January 24, 1986
JVM-86-017

Subject: Transmittal of Further Information in Support of
Topical Report NUH-001

I am sending with this letter the remaining information requested
by reviewers during our meeting of January 8, 1986.

NEUTRON ENERGY SPECTRUM FOR THE HSM AIR EXHAUST

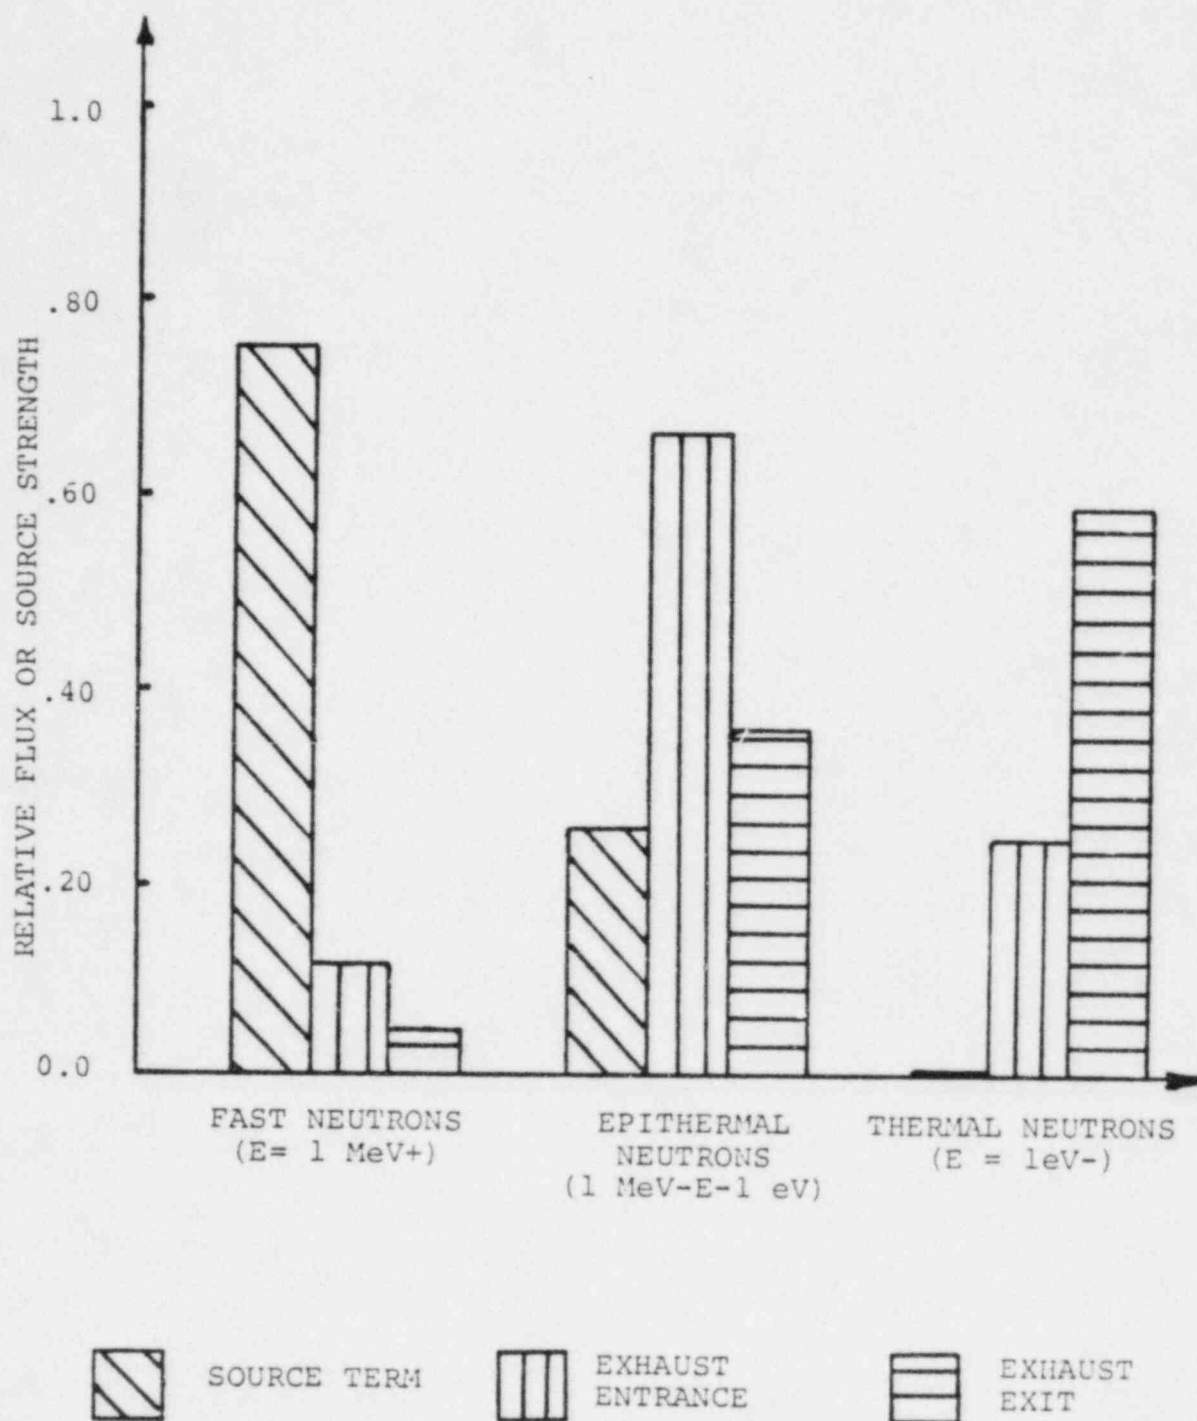
The attached table and figure illustrate the relative attenuation of gamma rays and neutrons as they pass through the HSM air exhaust vent, and the spectral behavior of the neutrons.

The well-thermalized nature of the neutron population at the air exhaust (refer to figure) indicates that the two-legged duct efficiently attenuates neutron radiation. Any significant streaming path would result in a higher proportion of epithermal or fast neutrons. (Compare the entrance and exit spectra).

The relative behavior of neutron and gamma ray radiation appears reasonable as modeled. Gamma peaking is more pronounced than neutron -- which is appropriate considering the differences in concrete albedo factors. Furthermore, the low exhaust exit neutron dose rate reported in the Topical Report is justifiable since the "softened" energy spectrum there indicates that no major streaming paths are present.
